National Emission Standards for Hazardous Air Pollutants for Coke Ovens: Pushing, Quenching, and Battery Stacks, and Coke Oven Batteries; Residual Risk and Technology Review, and Periodic Technology Review

ACTION: Final rule.

Committer’s Figure 1: Plot of door leak data from the EPA’s CAA section 114 request with assumed current and proposed values of PLD_{bench} only.

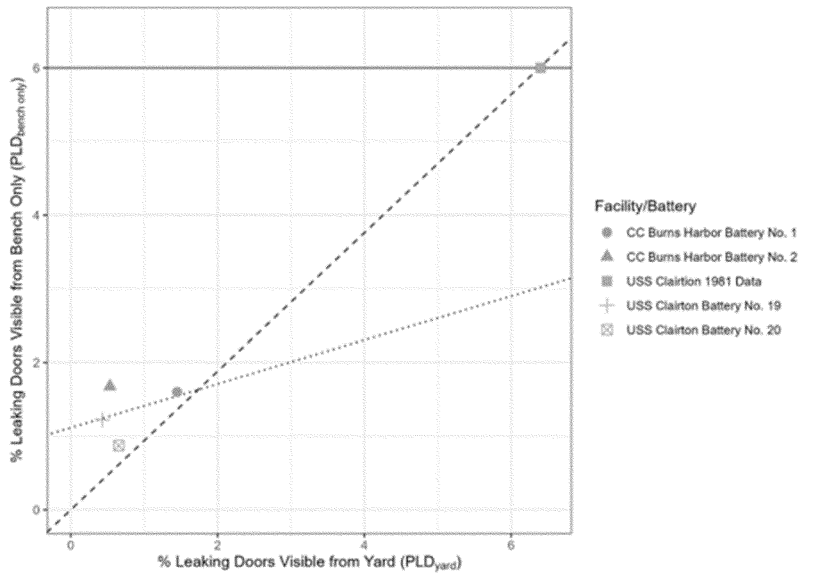
Comment: A commenter stated they believe the EPA’s proposed change to the equation for estimating leaks would underestimate PLD_{bench} and thus COE, and proposed an alternative equation. To test the EPA’s proposed change, the commenter plotted PLD_{bench} versus PLD_{yard} (shown in this section as Commenter’s Figure 1). The commenter asserted that for a valid equation the points should fall along a line with a slope of 0.94 and intercept of 0, and that because data for these four batteries in Commenter’s Figure 1 are above this line, the EPA’s proposed equation underestimates PLD_{bench} and thus COE.

The commenter continued that another issue is that the EPA’s proposed change assumes that PLD_{bench} is zero when PLD_{yard} is zero. However, even when there are no leaks visible from the yard, there will still likely be leaks visible only from the bench. It appears a more appropriate method for estimating PLD_{bench} from PLD_{yard} is to fit a line to the data with a non-zero intercept. Doing so yields the following equation for estimating PLD_{bench} from PLD_{yard} :

$$PLD_{bench} = 0.30 * PLD_{yard} + 1.11$$

Response: We agree with the commenter that there could be PLD from the bench, *i.e.*, PLD bench-only emissions, when PLD from the yard is zero. However, the term PLD_{bench} in the equation in the proposal materials represented emissions from the PLD from bench-only, see pg. 2 of the *Revised Equation to Estimate Coke Oven Emissions from Oven Doors* prepared for the proposal,²⁸ as well as the memorandum prepared for the final rule titled *Revised Equation to Estimate Coke Oven Emissions from Oven Doors-Final Rule*,²⁹ where it was stated that the
